**TOWN OF BROOKLYN
PLANNING AND ZONING COMMISSION
Meeting Agenda
Tuesday, January 16, 2024 6:30 p.m.**

ENGINEERING PLAN REVIEW PERTAINING TO A 7-LOT SUBDIVISION WAUREGAN ROAD (ROUTE 205) (ASSESSOR'S MAP 23, LOT 38) BROOKLYN, CT (December 13, 2023)

Northeastern Connecticut Council of Governments
ENGINEERING PLAN REVIEW
PERTAINING TO A
7-LOT SUBDIVISION
WAUREGAN ROAD (ROUTE 205)
(ASSESSOR'S MAP 23, LOT 38)
BROOKLYN, CT
(January 4, 2024)

Site Development Plan "7 Lot Subdivision"

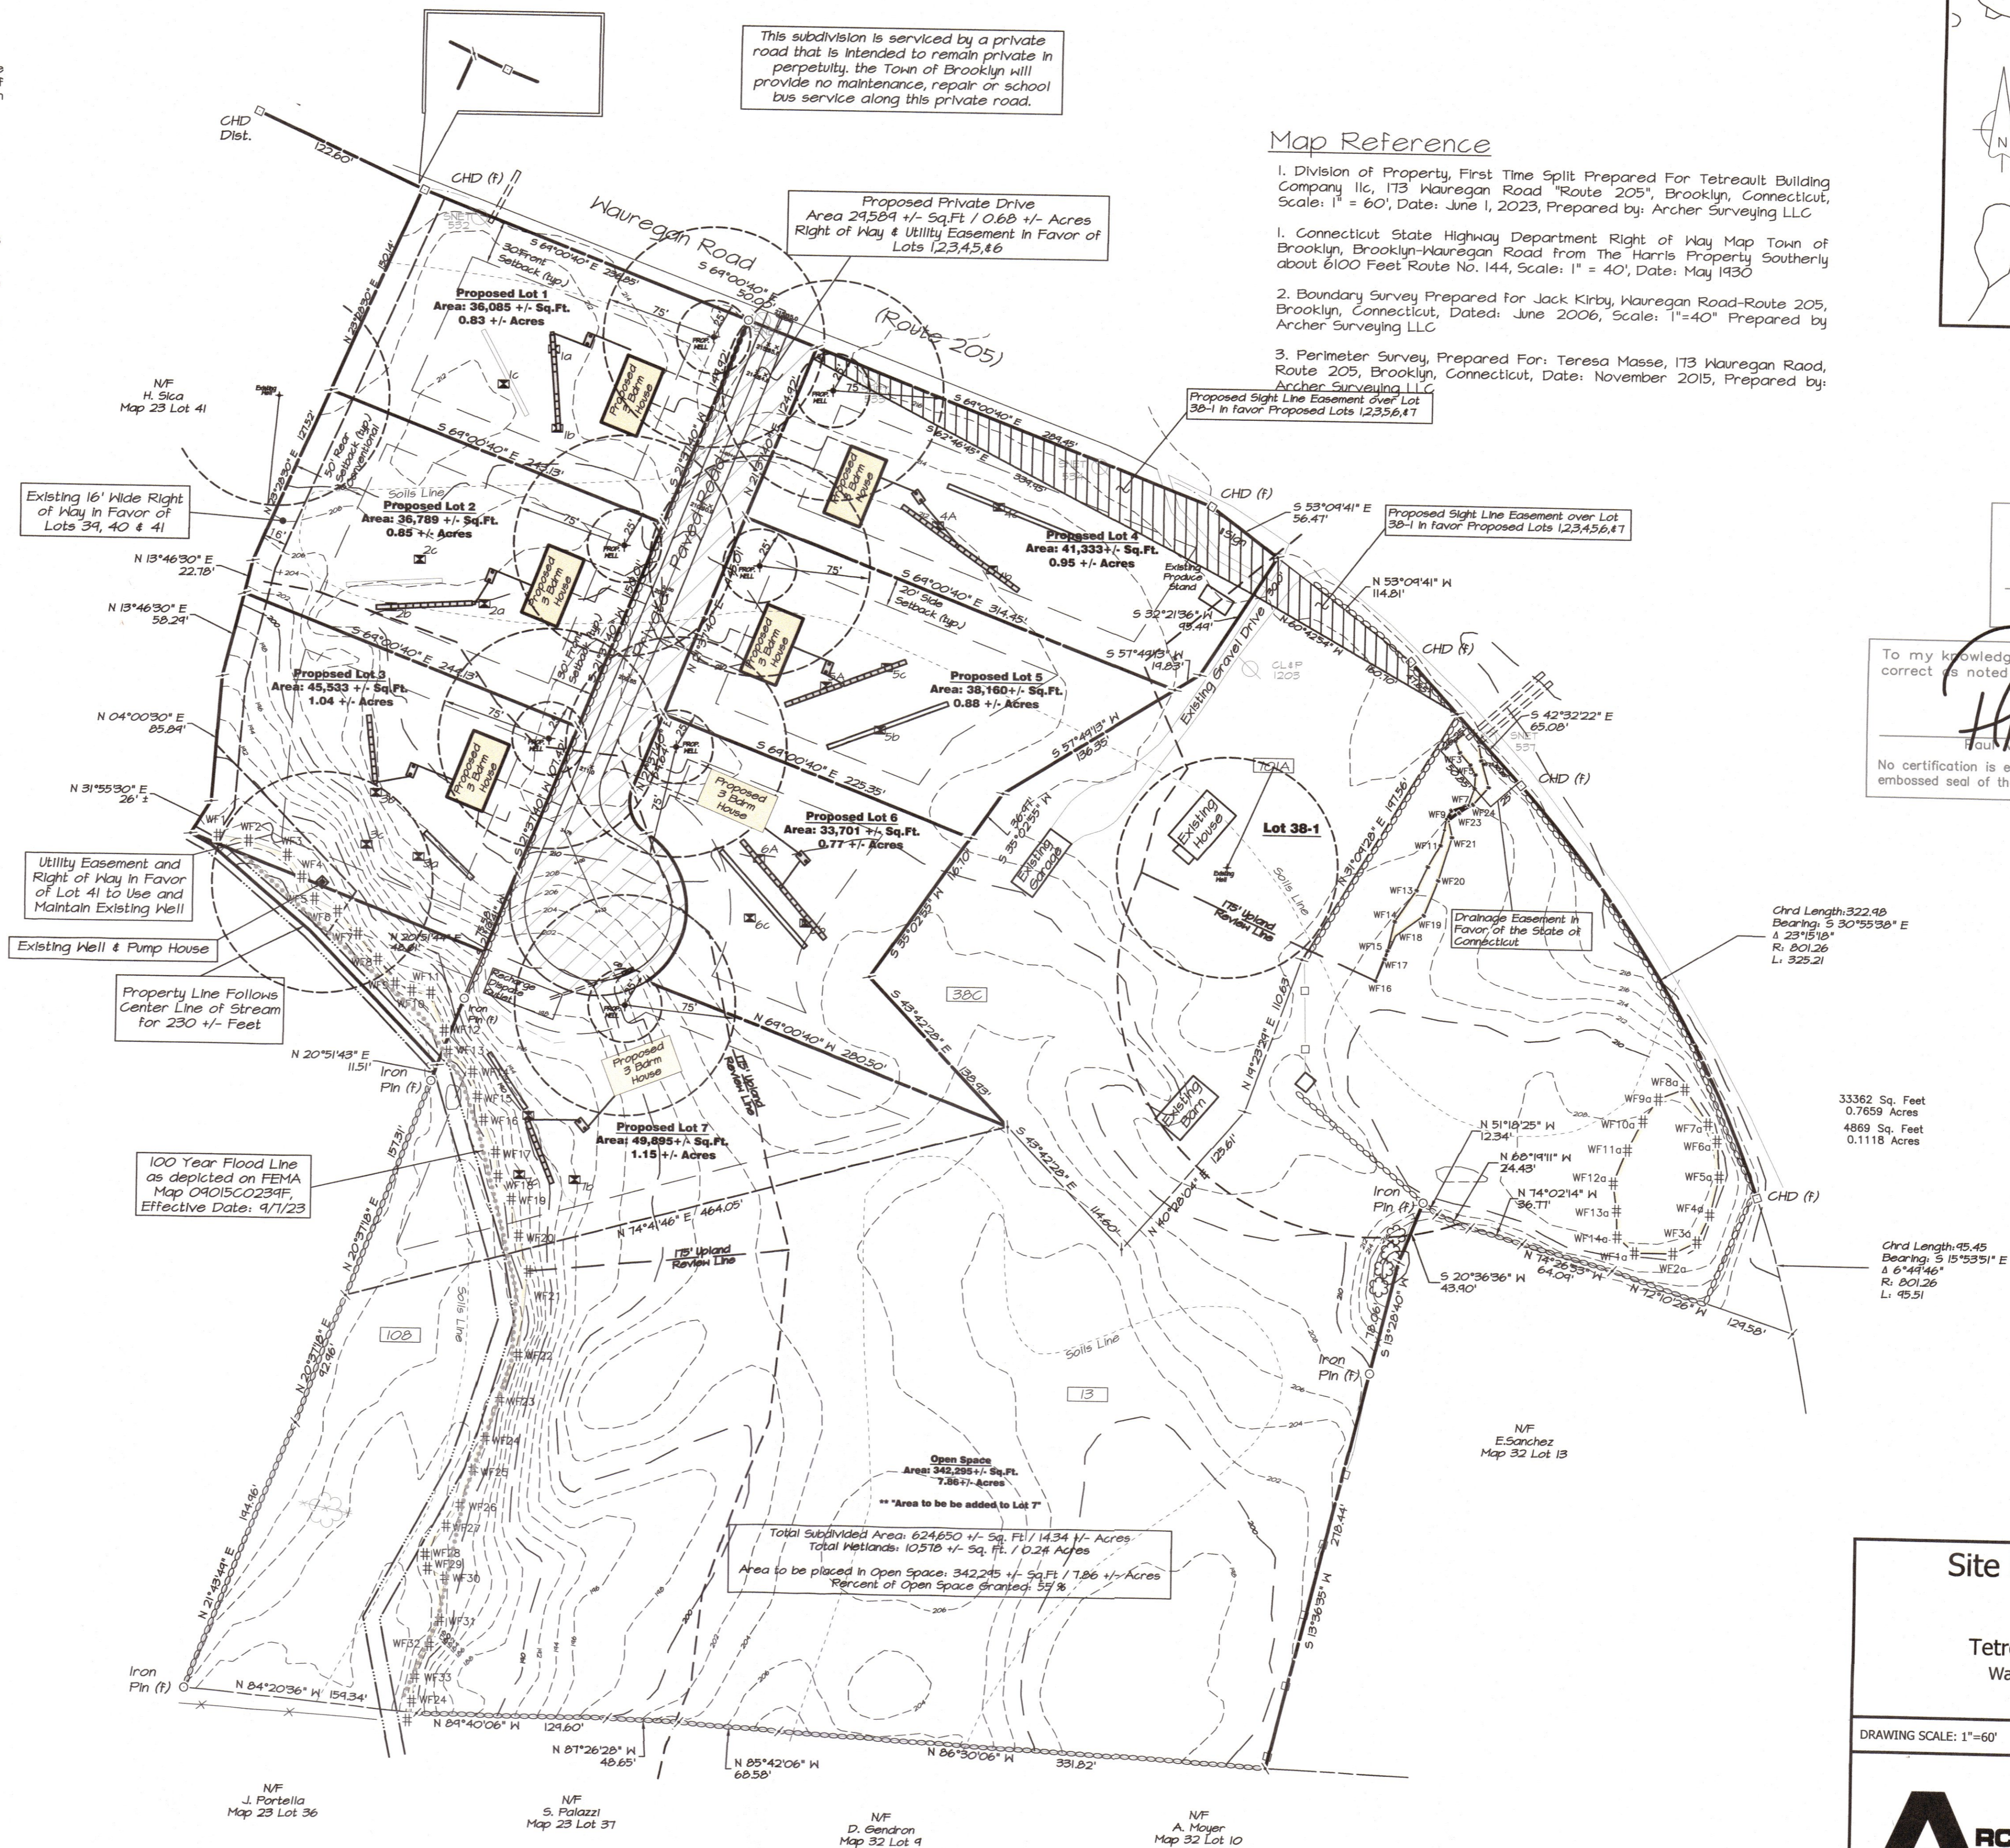
Site Development Plan

1. The Wetland Upland Review Area limit is missing and needs to be added to the plan.
2. The reserve septic system on proposed Lot 3 is within 75' of an existing well.
3. The FEMA 100-year flood zone needs to be added to the plan.
4. When was the wetland flagged by Joseph Theroux?

Sheet 3A

1. Description of the drainage system is non-existent on the plan, which is unacceptable.
2. Terminating collected drainage into what amounts to a drywell and noted on the plan as a "manhole" is unacceptable. Drywells fail in rather short time because they are not maintained and a biomat may form in surrounding soil thus preventing efficient absorption into the soil. Furthermore, used in this manner, it may be regulated by the state Underground Injection Control Program. Water collected in the engineered drainage collection system needs to be directed to an onsite detention (not retention) basin size for the 100-year event in this subdivision. Drainage calculations need to be included in a written comprehensive report that analyzes site pre- and post-development conditions, drainage pipe sizing and the retention basin sized up to and including a 100-year design storm.

3. Terminating collected drainage into what amounts to a drywell and noted on the plan as a "manhole" is unacceptable. Drywells fail in rather short time because they are not maintained and a biomat may form in surrounding soil thus preventing efficient absorption into the soil. Furthermore, used in this manner, it may be regulated by the state Underground Injection Control Program. Water collected in the engineered drainage collection system needs to be directed to an onsite

4. Catch basin inverts, pipe slopes and pipe lengths need to be added to the plan.
5. Proposed grading in the cul-de-sac turnaround does not indicate that water will be prevented from entering the driveway of Lot No. 7. The grading needs to be reviewed and shown on the plan preventing this. As drawn the proposed grading is unacceptable at this location.

6. All proposed grading needs to be refined around the house placeholders and added to the plan.
7. Percolation test locations need to be added to the plan.

8. Make the Wetland Upland Review Area limit line bold to stand out by itself. As drawn, it is the same line weight as a contour line, which makes it difficult to distinguish from that.

9. Why are houses at Lot Nos. 1, 4, 5, and 6 designated as being "slab on grade" and the remaining lots having full cellars?
10. Proposed grading in the cul-de-sac turnaround does not indicate that water will be prevented from entering the driveway of Lot No. 7. The grading needs to be reviewed and shown on the plan preventing this. As drawn the proposed grading is unacceptable at this location.

Sheet 3A - All addressed except for Nos. 5 & 10. A proposed spot elevation is needed at driveway entrance to show water will not enter the driveway.

Subdivision Plan

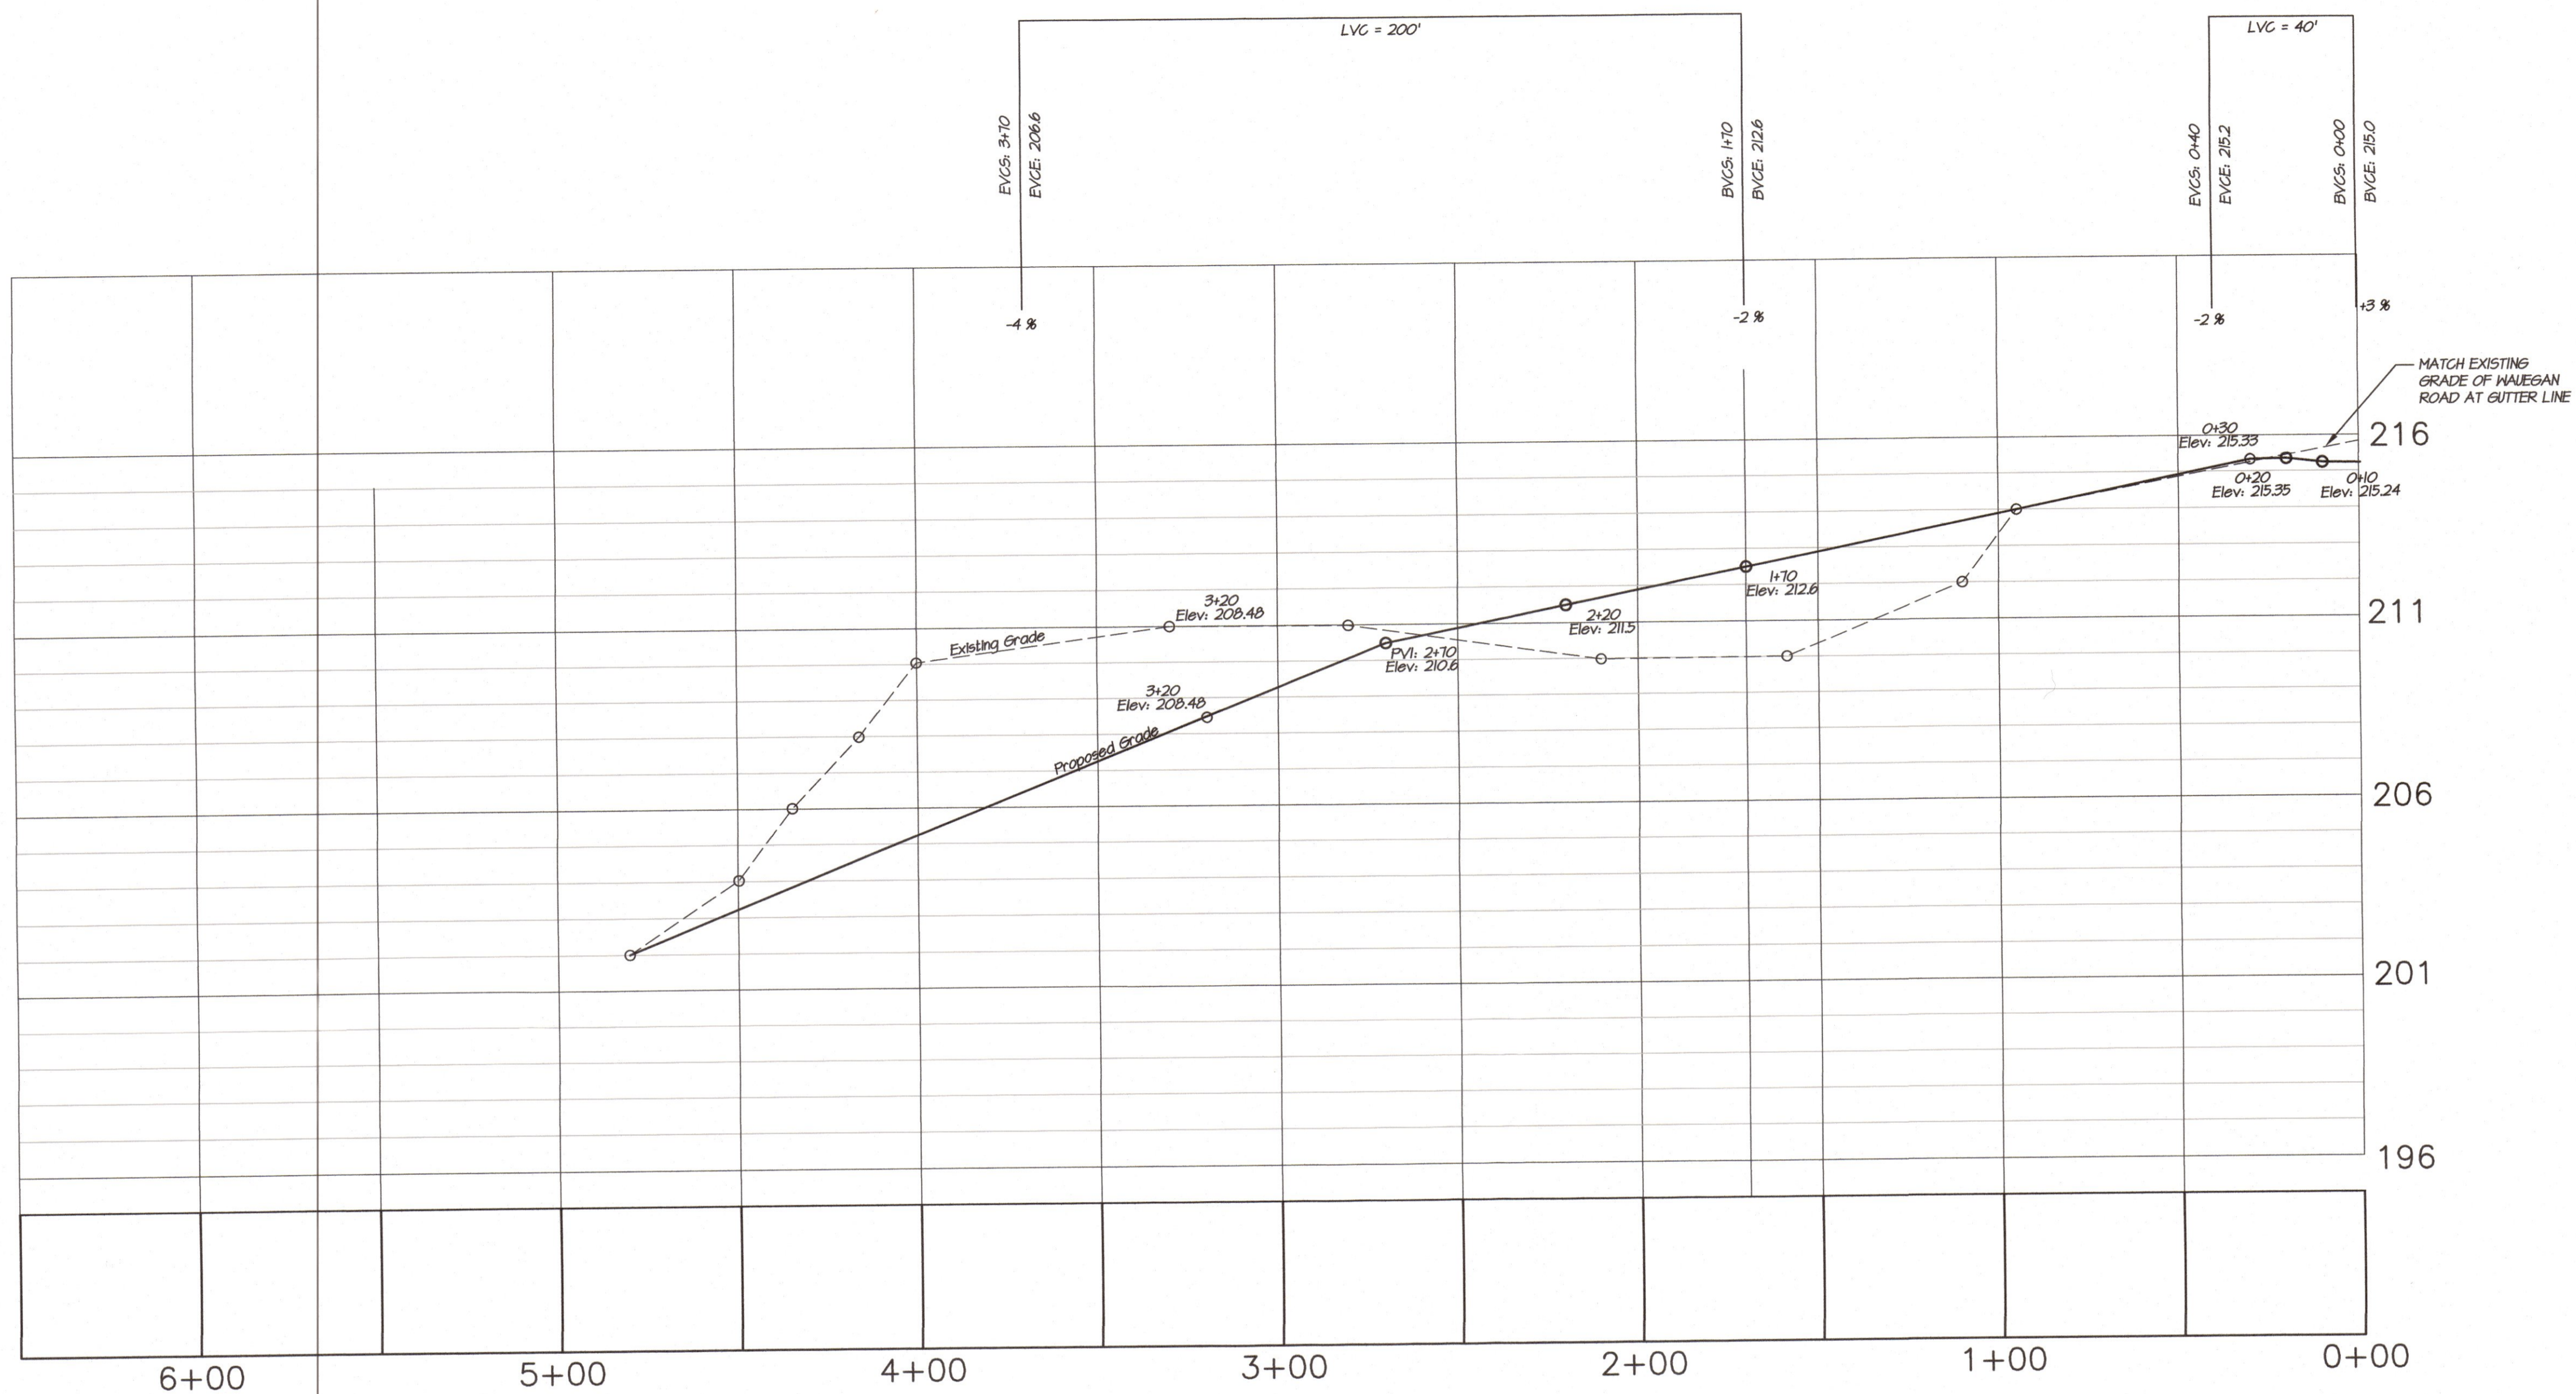
1. Not all Conservation Subdivision regs have been met, regarding Section 5.A.5, Dimensional Standards, and Section 5.A.6., Road Requirements.
2. It appears that water will pond in front yards of Lot Nos. 5 & 6 on Sheet 4 of 9.
3. Percolation test and soil test pits are needed at catch basins and discharge basin.
4. Dimensions and grading are needed at discharge basin on Sheet 4 of 9.
5. Location of the well on Lot No.7 on Sheet 3 of 9 is not the same as drawn on Sheet 4 of 9 and needs to be corrected.
